Attachment 1 to Holtec Letter 5025058
HI-STORE RAI Part 5 Responses September 2020

RAI 2-6 Provide information and design characteristics of each pipeline near the proposed facility site, including the new proposed pipeline, as described in SAR Section 2.2.2 "Pipelines." Information is also necessary for the temporary flexible pipeline currently at the site if the pipeline would be simply moved to an offsite location near the proposed facility during construction and operational phases of the proposed facility and would continue to operate in the new locations. In additions, information is needed for other temporary flexible pipelines close to the proposed site.

Figure 1: Oil and Gas Wells within 1 mile of HI-STORE Facility

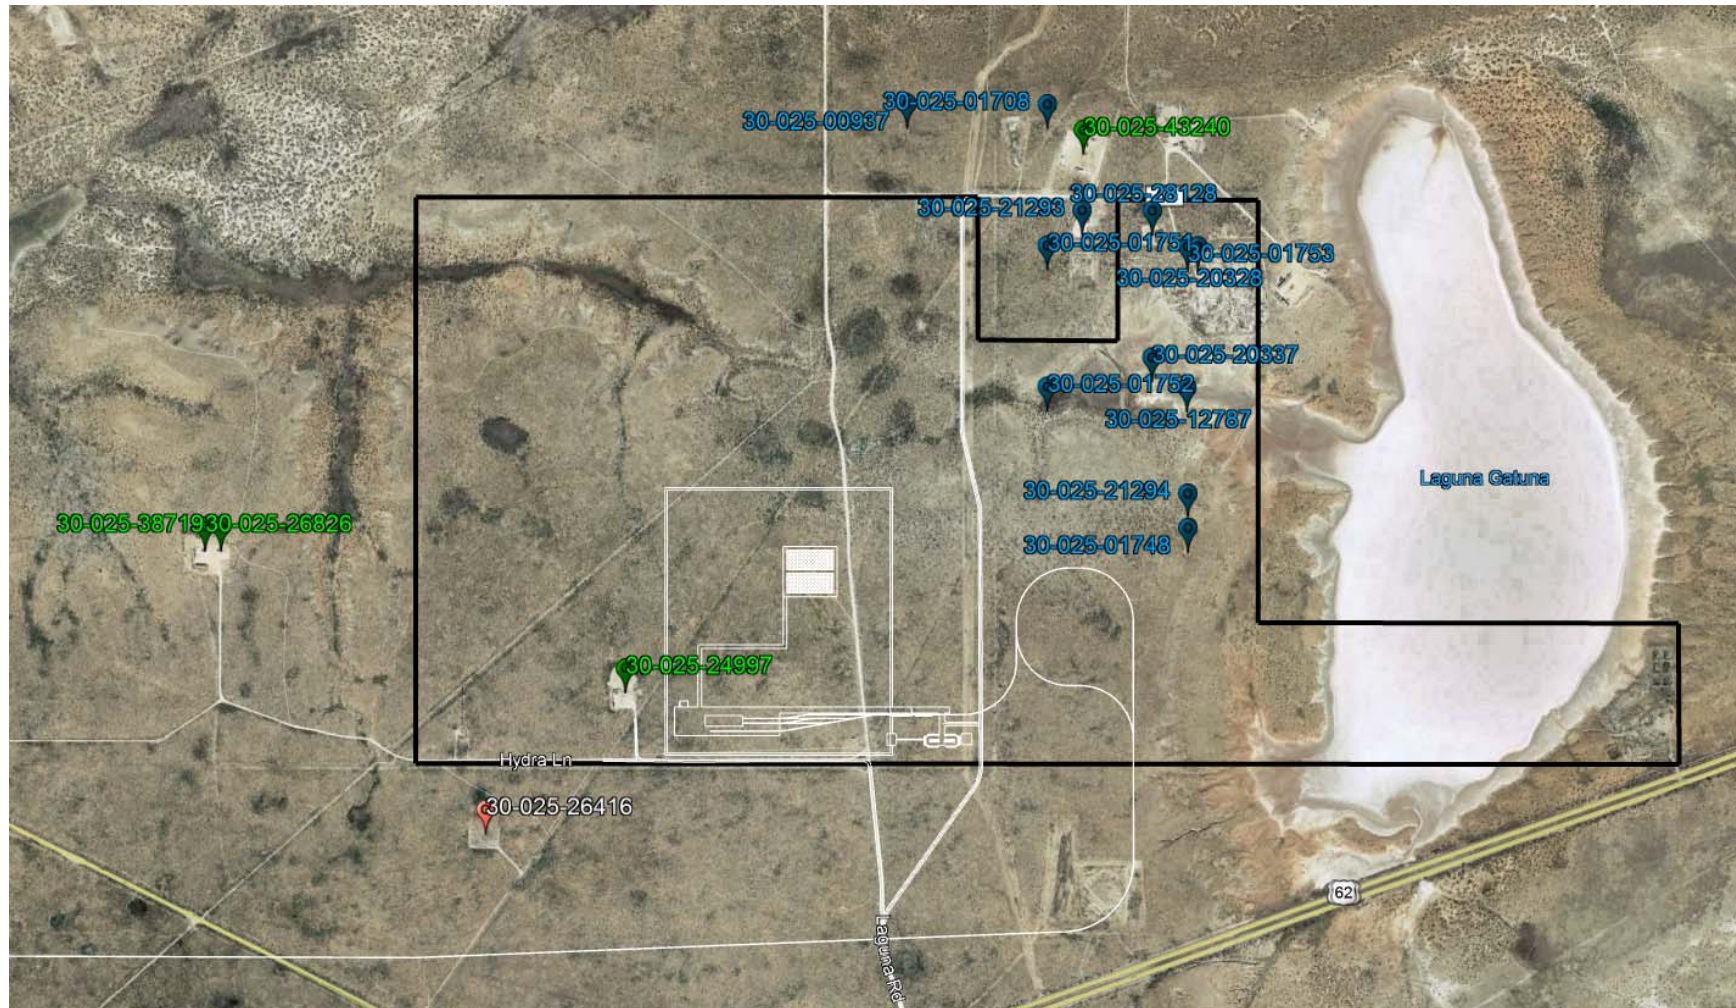
Table 1 below shows the relevant information for all oil and gas wells within 1 mile of the facility including their approximate distance to the ISFSI [3]. Figure 1 shows their relative location to the proposed HI-STORE Facility. As noted, there is 1 active gas well, 3 active oil wells, 12 plugged oil wells, and 1 cancelled oil well (never drilled). Note, information on the regional stratigraphy can be found in SAR Section 2.6 and Section 3.3 of the HI-STORE Environmental Report.

Based on the above information, there is little to no potential for hazards to important-to-safety structures at the proposed facility from oil and gas well activity including existing plugged wells, currently active producing wells, and any future well exploration and production activities. The above information in Table 1 and Figure 1 has been added into SAR Section 2.1.

Figure 1 –Order 3324 Buffers for Oil and Gas Wells in the Secretary's Potash Area in the vicinity of the HI-STORE CIS Facility [1][2]

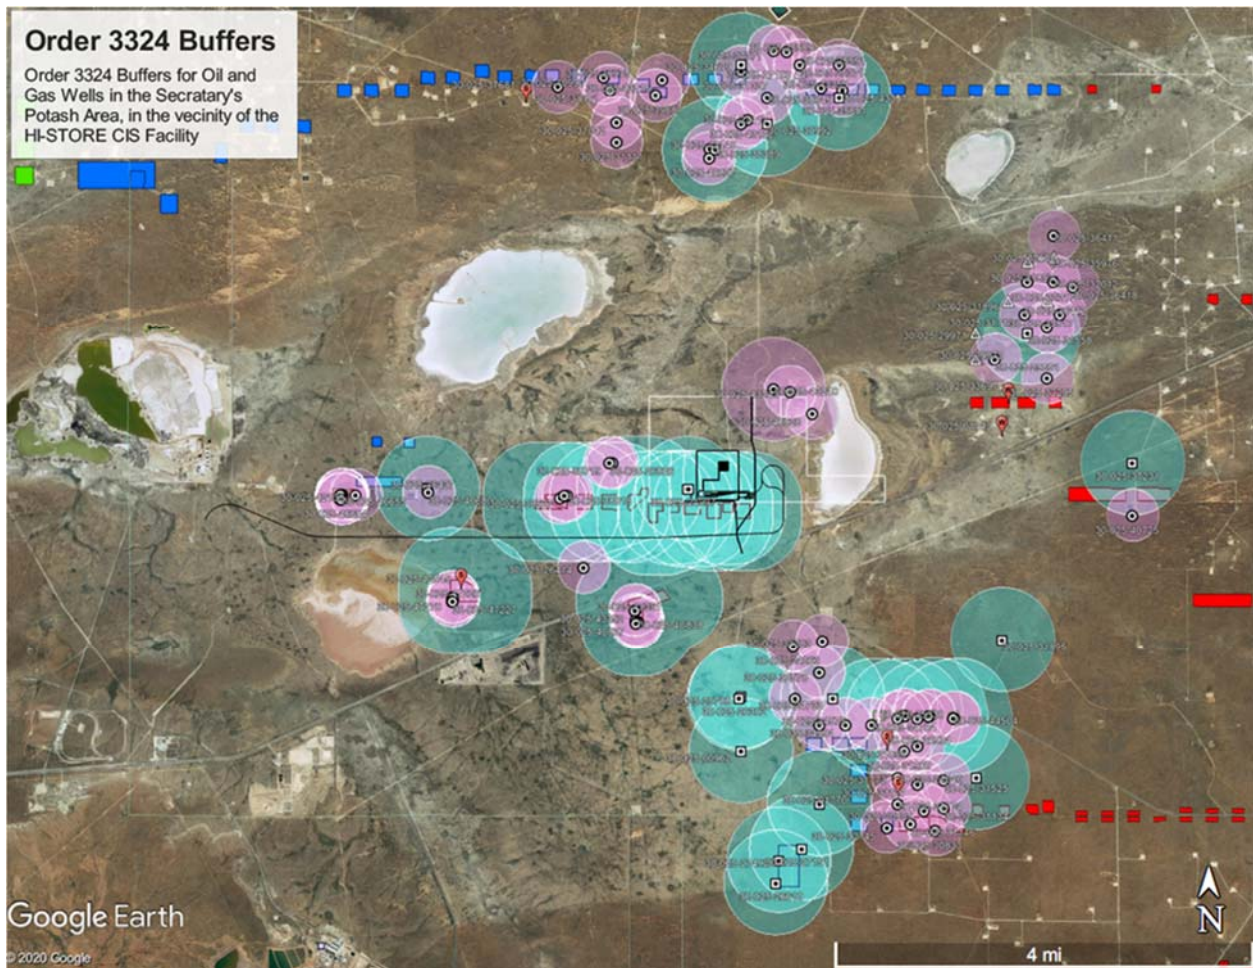
2-12: Provide a rationale for why mining operations at nearby underground potash mines or extraction of oil and gas from underneath the CISF would not pose any hazard to the proposed facility from surface subsidence. Also, justify why mining of potash would not be feasible beneath or around the proposed CISF site for the proposed duration of the license.

1. Location of potash mines (SAR Figure 2.1.23).
2. Current inactive status of the closest mine workings. The closest mine workings approaching the mining accessible side (west) of the site are part of the Intrepid North facility and are not actively mined. The facility is used for surface operations only.
3. Distance mines would have to be extended to affect the facility;
4. Location of the vertical well buffers, Figure 1 (new SAR Figure 2.1.24).

Discussion of Order 3324 added to SAR section 2.1.4. Figure 2.1.24 added to show drill island buffer zones.

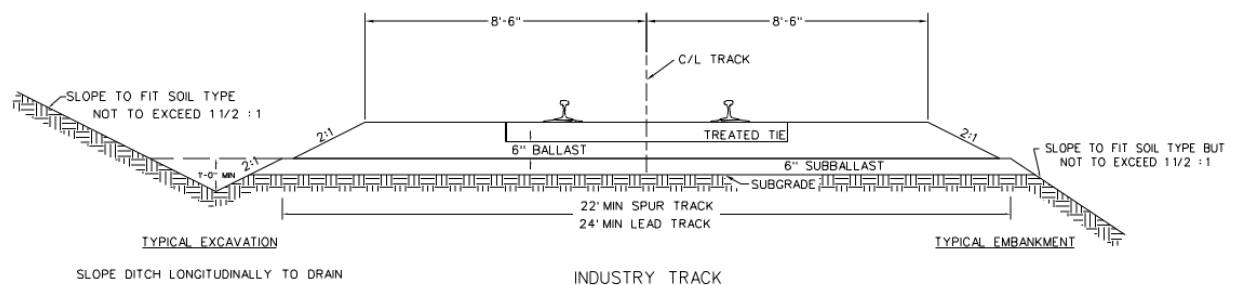
2-22: Provide additional information describing the proposed rail track and embankment that will connect the proposed CISF with the existing railway spur (SAR Figure 2.1.5). The information should include elevations of railroad embankment, any hydraulic structures incorporated into the embankment, and design parameters of the hydraulic structures if applicable. Also provide information on the likelihood of failure for the rail track and embankment during extreme weather events, e.g., a PMP, and the effect of such failure to the flooding of proposed CISF on-site structures, systems, and components.

Section 2.1.2 of the SAR state that “aerial view of the site is shown in Figure 2.1.5 and several plot views of the HI-STORE CIS Facility with all phases complete are shown in Figures 2.1.6(a), (b), and (c).” Figure 2.1.5 of the SAR indicates that a rail track is proposed to connect the proposed CISF to an existing rail spur to the west of the site. Figure 2.1.6(a) of the SAR indicates that the proposed rail track will run between the proposed CISF and Laguna Gatuna but does not provide the elevation of the rail track and any potential hydraulic structure incorporated into the railroad embankment.

The rail track that will be constructed for the HI-STORE Facility will tie into the existing track approximately 5 miles west of the site. The existing track services the Intrepid Potash North Facility and is operated by BNSF Railways. HI-STORE Rail track shall be designed for the applicable loads in accordance with BNSF guidelines and specifications [1]. The rail will generally follow the natural terrain with the embankment kept to a minimum and graded to maintain the requirements of the BNSF Standards. A figure illustrating the standard embankment design for the industry track, is shown below [1]. Drainage features, including culverts where necessary, shall be installed beneath the embankment in order to maintain current drainage. The drainage features shall be sized in accordance with BNSF specifications. For culverts specifically, the specifications state:

“The minimum diameter for all culverts installed under main tracks or tracks maintained by BNSF is 36 inches. This is to accommodate regular inspection and cleaning. Culverts maintained by the Customer should be 24 inches or larger.” [1]

Figure 2.1.10 has been revised to illustrate the HI-STORE Facility, including the portion of the rail line between the facility and Laguna Gatuna, in relation to current site topography.

Figure 2.1.2: HI-STORE CIS Facility Site Boundaries [2.1.3]

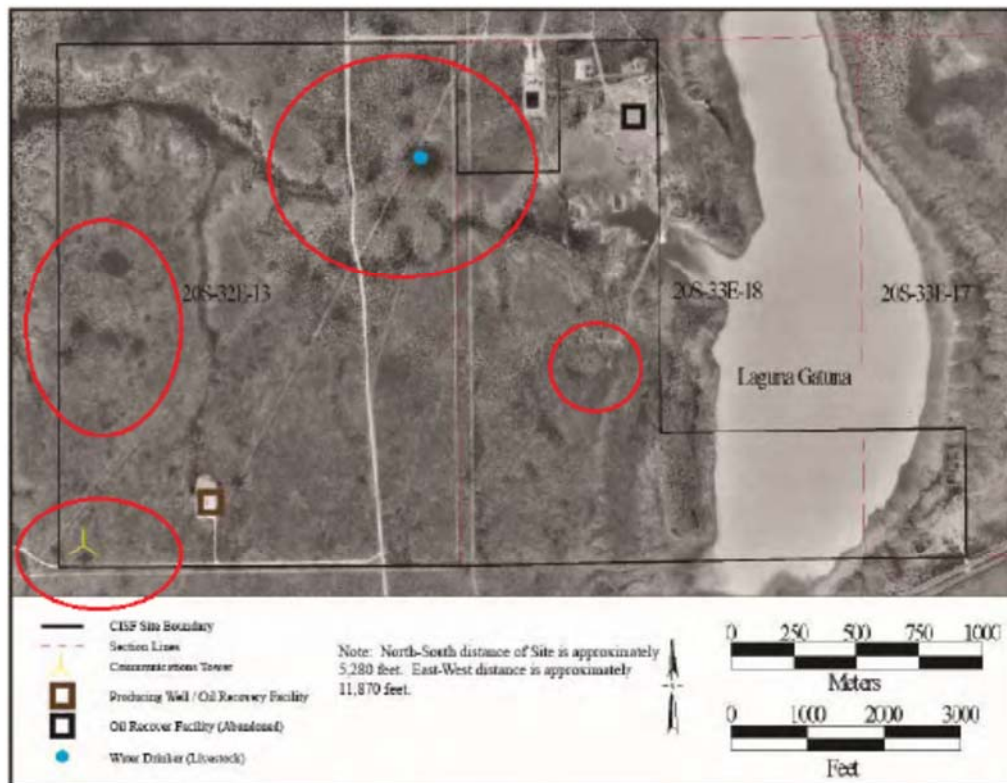
Figure 2.6.2 of the SAR shows the site is underlain by over 1,000 feet of the Capitan Reef, a carbonate formation in the site region that is well-known for the large-scale karst features that have developed at the surface and at depth. Most notable of these features is the Carlsbad Caverns, approximately 65 miles southwest of the site. The staff also notes the presence of additional carbonate and evaporite rocks both above and below the Capitan Reef and the association of subsurface halite dissolution above the Capitan Reef with several sinkhole features in southeastern New Mexico. Additionally, SAR Figures 2.1.2 and 2.1.5 show numerous circular features throughout the site and surrounding areas but the application does

not discuss the origin of these features. On Figures 2.1.2 and 2.1.5, these features are indicated by red circles. The green box on Figure 2.1.5 is the general outline of the area covered by Figure 2.1.2.

The features identified by the NRC in RAI 2-26 are localized surface depressions generally without surficial drainage outlet and are typically about 2-foot deep or less, and less than 100-feet across in plan dimension. Ground surface elevation changes are often subtle at the edges of these depressions. In the vicinity of the Site these depressions can generally be identified based on vegetation changes when compared to the surrounding area, which is likely attributable to these depressions intermittently holding water, as indicated by the USGS topographic maps and aerial photography. The locations of these depressions relative to the Site are shown in Figure 2.6.17.

Clarifications have been made to section 2.6.4 to highlight this discussion. Figure 2.6.17 has been added to show depression features.
